FW: Powerpoint Presentation from Today's Meeting (proposed Goliad County Aquifer

Exemption)

Technical Meeting Goliad Exemption 8-16-12

Issues with the latest submissions

Figure 4.7. Water level drawdown and recovery in Troil observation wells for the PTW-6 test.

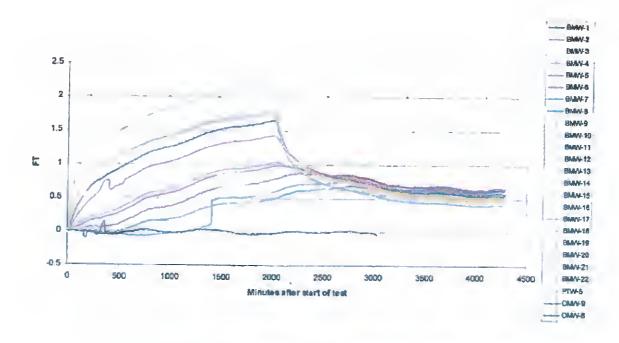
Results of PTW-6 pump test

- · Shows good communication with monitor well ring
- Indicates hydraulic isolation with OMW-9 completed in A sand
- Results of second OMW-8 is not clear

Can pump tests be relied upon to find hydraulic isolation between A and B sands exists?

- Distance between pump test well PTW-6 and OMW-9 showing good isolation is approximately 125'
- There is a much greater distance between the test and down gradient wells of concern
 - Distance to the Braquet well is approx. 1400'
 - Distance to the Church wells is approx. 2300'
- Pump test using PTW -6 is simply too far away to extrapolate results to wells of concern
